CITY OF LONDON KENY ROAD EXTENSION PROJECT

Re: Keny Road Extension Project / Madison County

This letter is written regarding the construction storm water inspection that I conducted of the Keny Road Extension project on October 20, 2010. The purpose of the inspection was to evaluate compliance with the General Storm Water Permit Associated with Construction Activities. During the inspection, I noted the following issues associated with construction activities at this site:

**Keny Road Extension
Stabilize barren areas
Install silt fence
Deer Creek Watershed
October 20, 2010
Photo by: Greg Sanders**

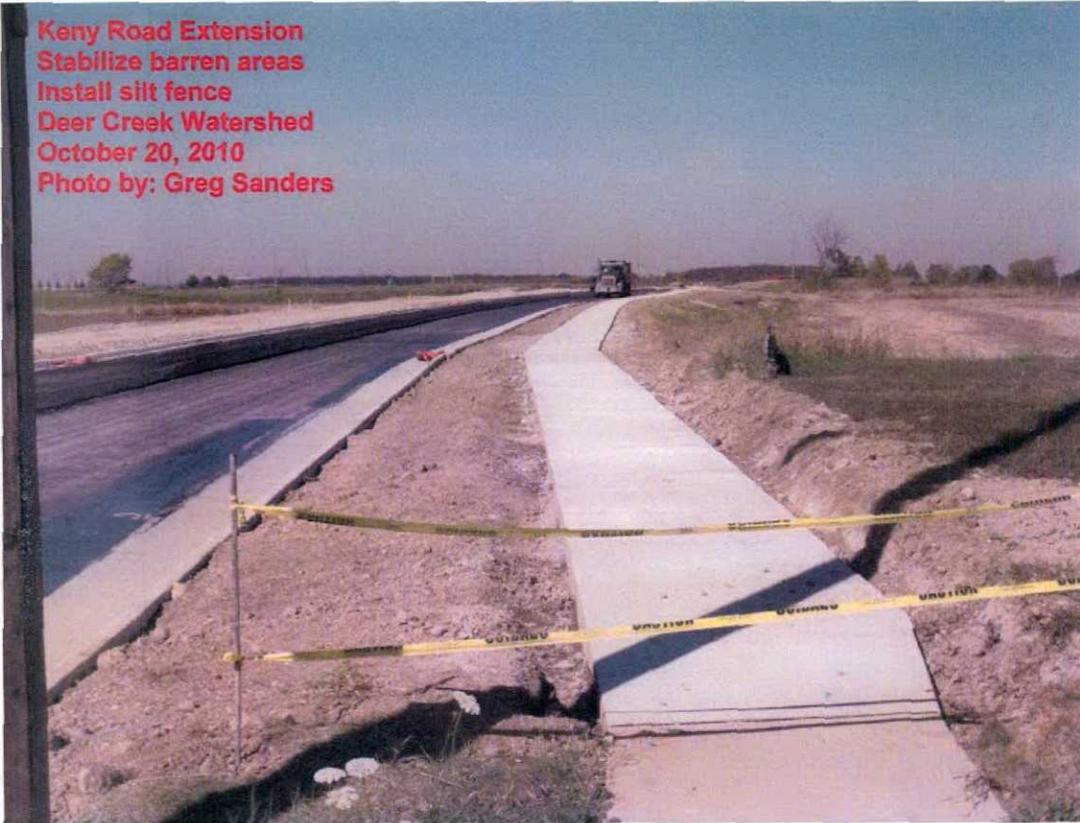
**Keny Road Extension
Stabilize barren areas
Install silt fence
Deer Creek Watershed
October 20, 2010
Photo by: Greg Sanders**
